Sheet: /
File: 002.35.25.05.20-001-PCB-SolarTele.kicad_sch

Title: 15V/5V Regulator, RF Power Detector, and Non-Inverting Amplifier

15V/5V 1A Power Supply

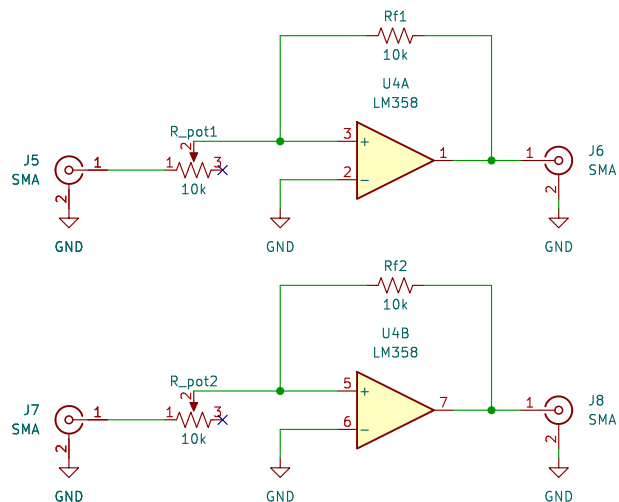
On the final design, L7815 --> L7812 because 15VDC cooling fans were not available.
Op-amp topology is wrong; if the board is to be reprinted, this must be corrected.
